Field Service Bulletin Trucks

Flasher Replacement CHU, CXU, GU, TD

FSB 364-036, Flasher Replacement

(June 2013)

W3082443

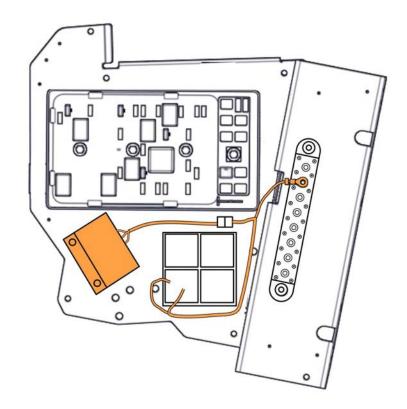
Mack is removing the flasher 20971013 from production and the aftermarket due to the durability issues of the flasher. The 20971013 flasher will be replaced by 25162061 in the aftermarket. This will increase the reliability of the flasher circuit and the vehicle. Follow the procedure to replace the flasher if needed.
